UNITED STATES ATOMIC ENERGY COMMISSION

REPORT TO ADVISORY COMMITTEE ON REACTOR SAFEGUARDS

INDIAN POINT NUCLEAR GENERATING UNIT NO. 2

REPORT NO. 4

Figure 1

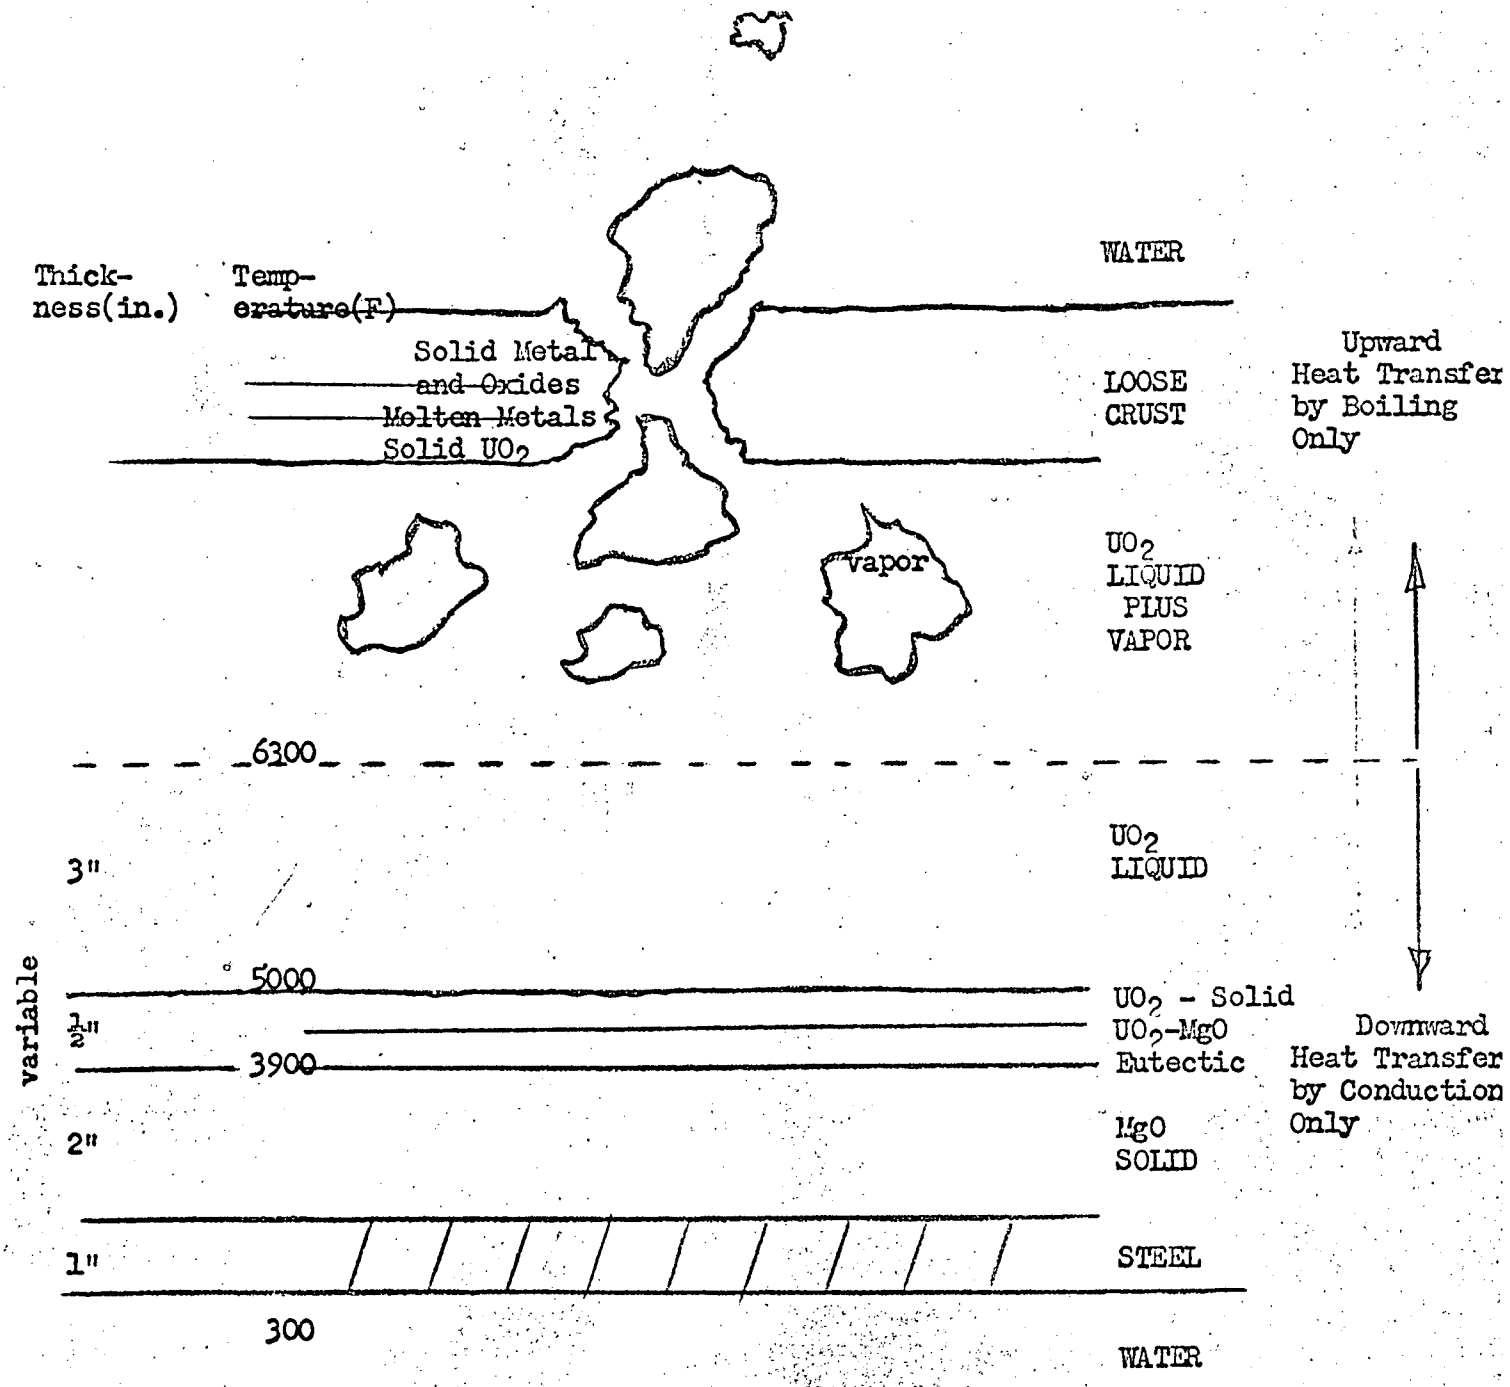
1. An evaluation of the concept requires further information regarding the fundamental heat transfer mechanisms (which may not be easily obtainable).
2. The model presented is highly sensitive to the amount of heat transfer downward through the bottom of the crucible. As the heat flux increases, the steel temperature increases and the amount of remaining

refractory material decreases (MgO above 3900F is assumed to float to the top of the melt). The applicant's simplified approach for evaluating this quantity leaves much to be desired.

3. The applicant does not state, nor do we know, the limiting thickness of refractory material necessary or the limiting steel temperatures before failure of the crucible can be assumed.

Figures 1 and 2 summarize the applicant's model and the results of our independent calculations using the model. Figure 1 presents the basic model with necessary explanatory information. Figure 2A shows the thickness of refractory remaining and the maximum steel temperature (at MgO-steel interface) as a function of downward heat flux. Figure 2B shows the downward heat flux as a function of percent of full power (decay heat rate) and the parameter "k." This parameter is the assumed conductivity of liquid UO_2 which is used in the simple conduction model for estimating downward heat transfer. As we increase the value of "k," we are essentially assuming added heat transfer mechanisms in the downward direction (due, for example, to convection currents). With the information we presently have available, it is difficult to predict the value of "k" which should be used in a simple conduction model. The applicant proposes to use a maximum value of 5.2 Btu/ft-hr-F which is two times their presently accepted value for conductivity in solid UO_2 at the melting point. Considering the model assumes liquid UO_2 with convection currents, this value does not appear to be unduly conservative.
